**SITE PLAN REVIEW AND APPEARANCE BOARD
MEMORANDUM STAFF REPORT**

Project Name: Martini Property

Project Location: The request is in conjunction with the construction of a parking area and cross access to the north-south public alley from SE 4th Avenue (approximately 0.14 acres) at 59 SE 4th Avenue.

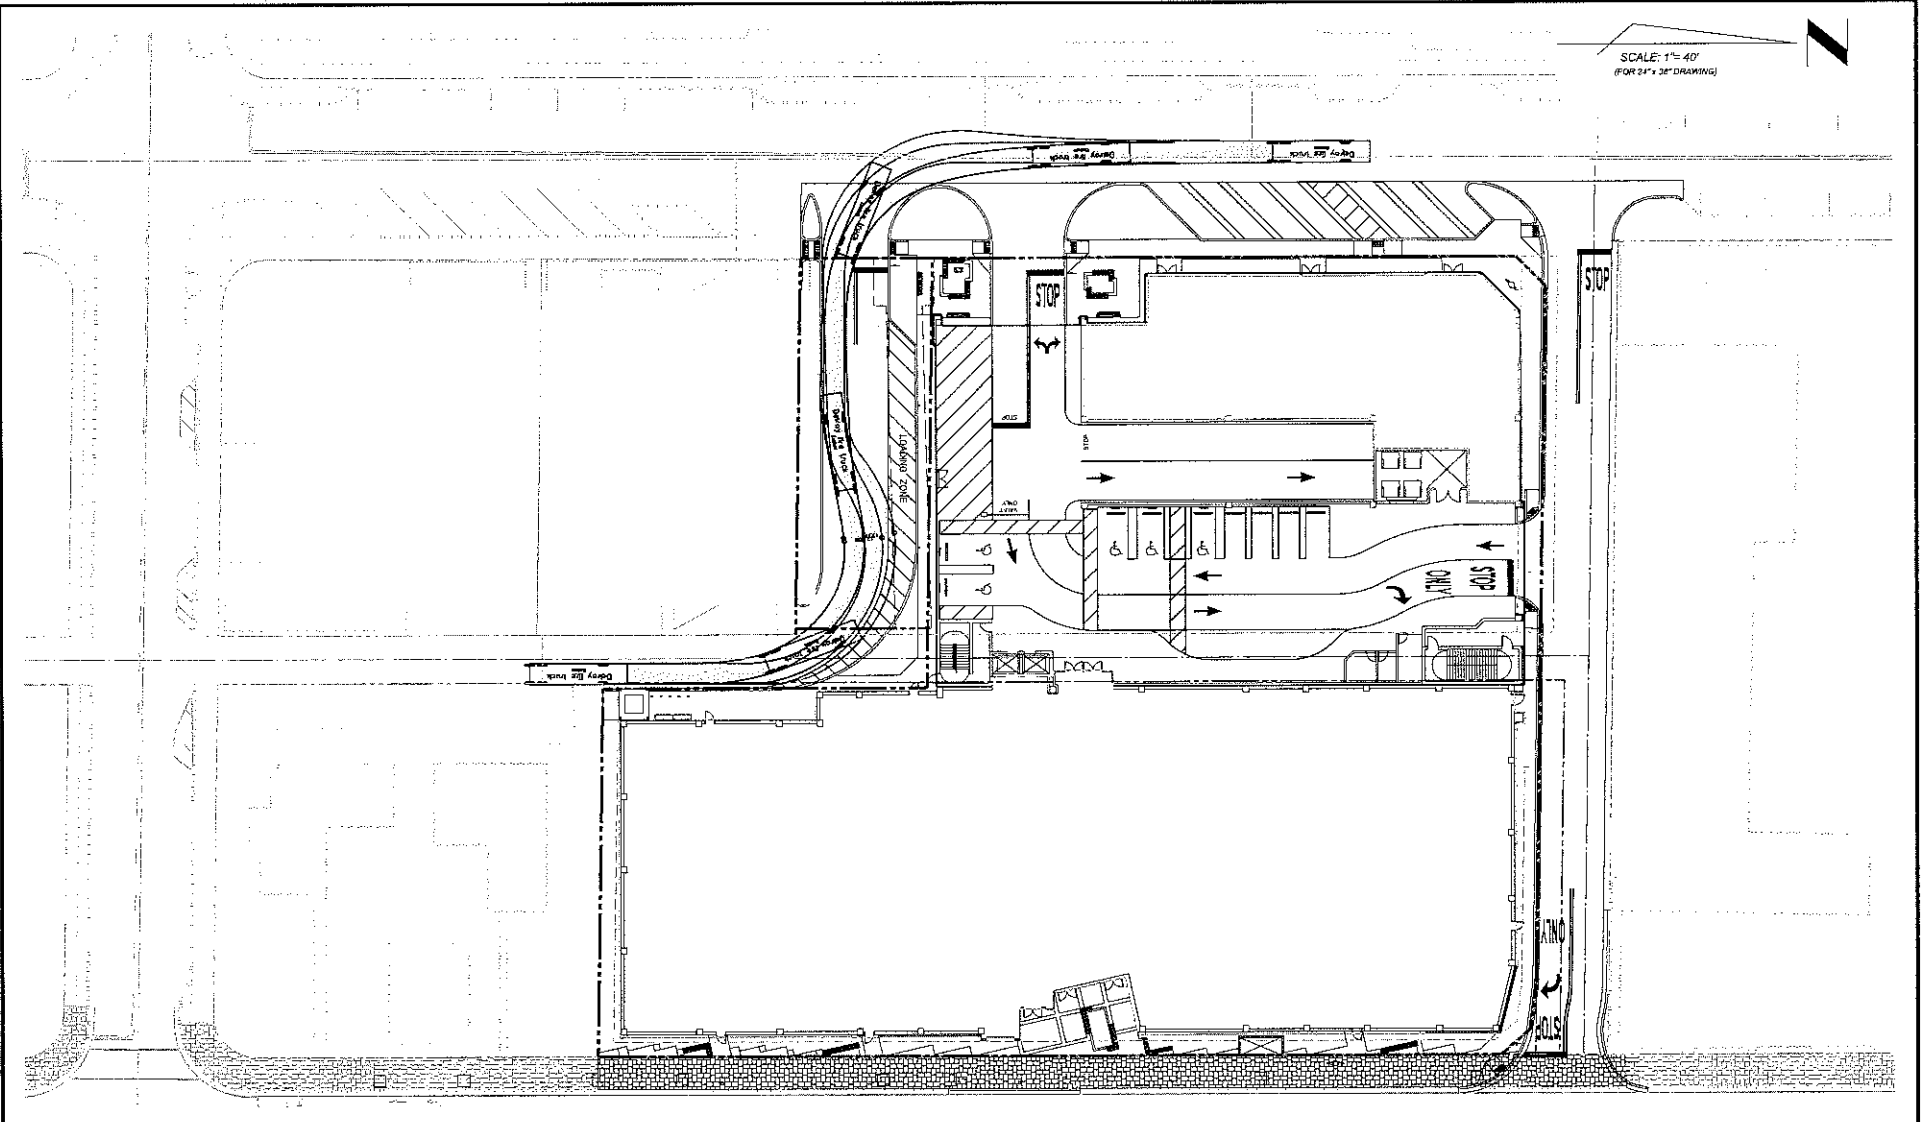
The site plan has been revised to depict the turning movement for emergency vehicles. The vehicles will have adequate turning radii to maneuver through the property, which will in part utilize the loading area.

LANDSCAPE PLAN
SCALE: 1" = 20'-0"

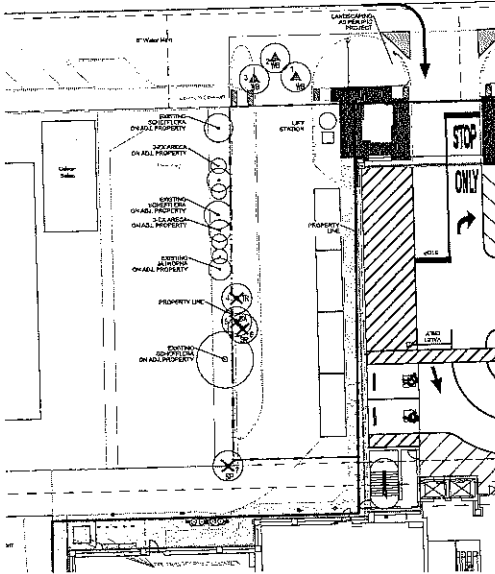
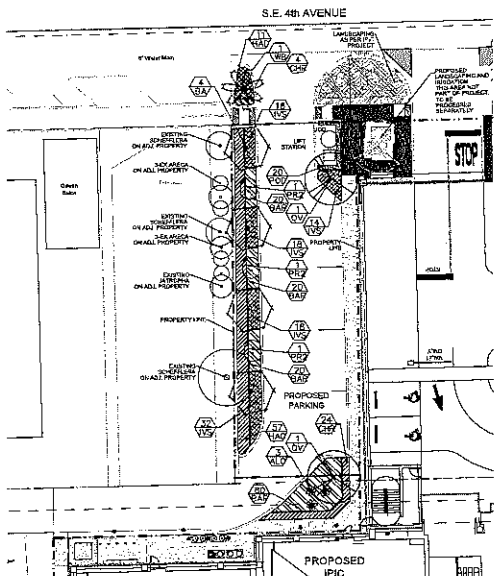
1. Tree #'s 1 -3 (city-owned Foxtail Palms) and #'s 6-7 (Sabal Palms) shall be saved either on-site or off-site. Update the Existing Tree Disposition plan to show final locations for all relocated trees. Provide a separate column entitled "Relocated To". Trees will either be relocated on-site or off-site. If off-site, provide an asterisk next to each tree with a note. The note shall read, "All trees to be relocated off-site shall be coordinated with the City of Delray

Beach a minimum of six (6) weeks prior to relocation. Call Peter Anuar, Senior Landscape Planner, at (561) 243-7226 for coordination."

2. Per LDR 4.6.16(E)(5), all required trees are to be a minimum of sixteen feet (16') in height with a seven foot (7') spread and eight foot (8') of clear trunk. Revise specifications and species if this size cannot be found for the species that is currently being proposed.
3. Landscape Maintenance Agreement is required for the proposed plantings outside the property line. Submit the signed agreement with the supporting exhibits (as outlined in the agreement) as quickly as possible. This will need to be executed by City Commission.
